RE: Application No: MP08_0195 78-90 Old Canterbury Rd, Lewisham - Preferred Project Plan

RE: Application No: MP08_0195 78-90 Old Canterbury Rd, Lewisham - Preferred Project Plan

I write on behalf of the No Lewisham Towers Inc (NLT) Committee to raise concerns, highlight errors and misleading information, and to express significant objections to the above Preferred Project Plan (PPP), currently before the Department of Planning and Infrastructure (DOPI) and available for viewing on your website.

SECTION A - A THROUGH VIEW 1

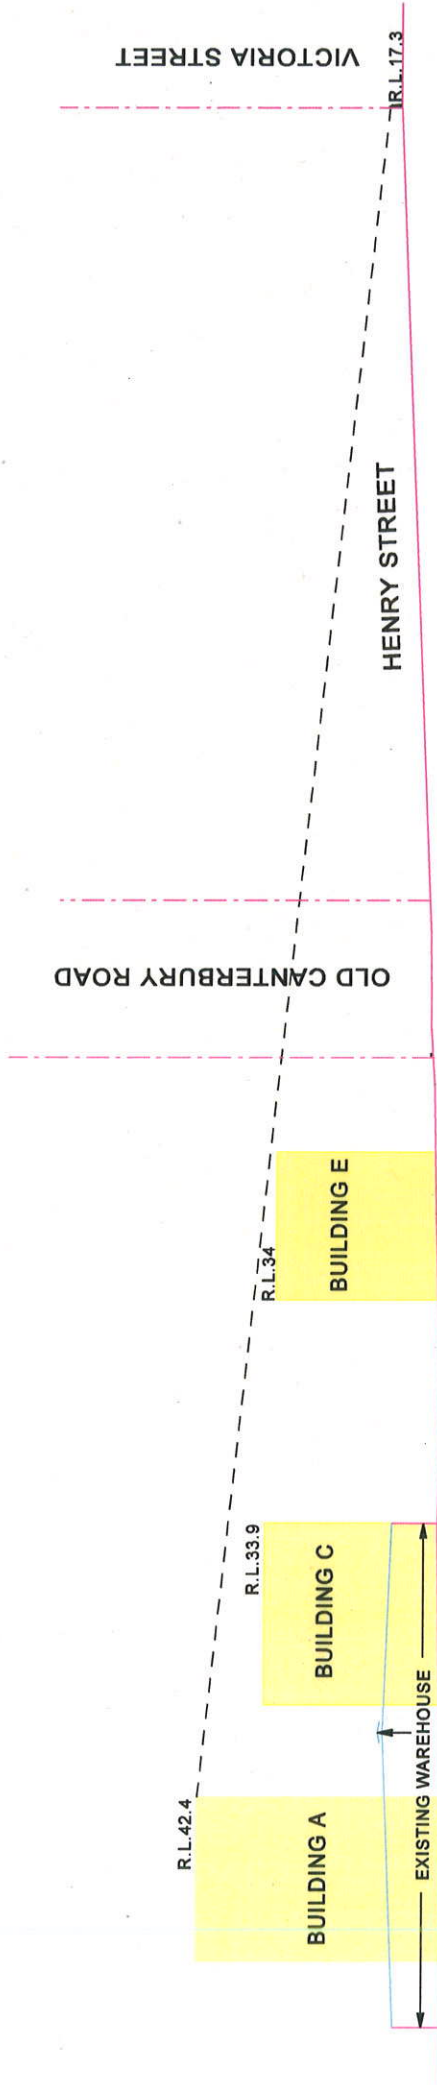
- an aerial photograph - showing the view line with the proposed new buildings superimposed in yellow,
- a section diagram – showing a section along the view line with the proposed and existing buildings indicated, and
- a copy of 14.1_View Analysis Study Plan – View 1 – showing a true representation of the impact of the proposed new buildings on the view. The attachments clearly demonstrate that the red outline depicting the proponent's version of the proposed building impact is grossly in error and that the true impact of the building is more than double the height depicted by the proponent.

14.1_View Analysis Study Plan

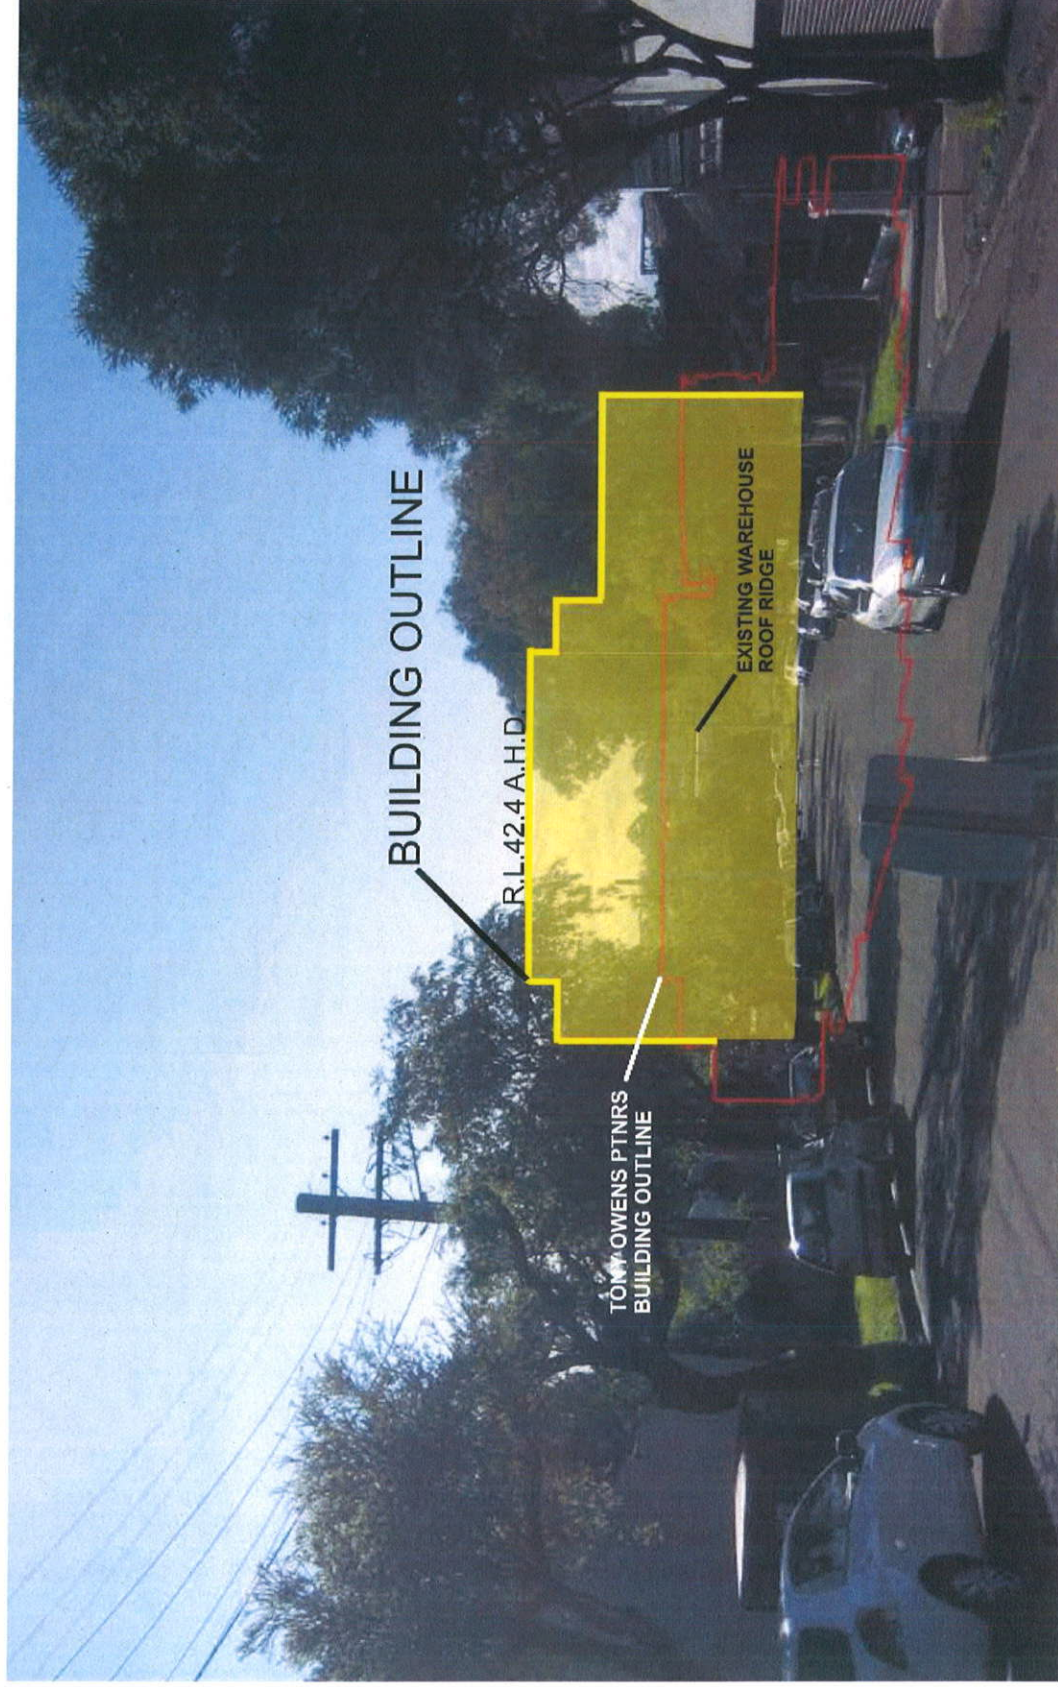
We have reviewed "View 1" of the "View Analysis Study Plan" and believe that "View 1" is a gross misrepresentation of the impact of the building contained in the proposal.

14.1_View Analysis Study Plan – View 1 shows a photomontage of the proposed view of the subject site looking in a north-western direction down Henry Street from the intersection with Victoria Street.

Due to the limited time and resources available to No Lewisham Towers Inc, we have only examined View 1 of the 8 view photomontages contained in the View Analysis. We believe the error demonstrated in our review of View 1 calls into doubt all the views contained in the analysis.

We request that all 8 views be checked and certified by an independent Registered Land Surveyor together with a comprehensive explanation of the procedure used to check each photomontage, and the outcomes be made available to the PAC and the community, clearly drawing attention to any inconsistencies.
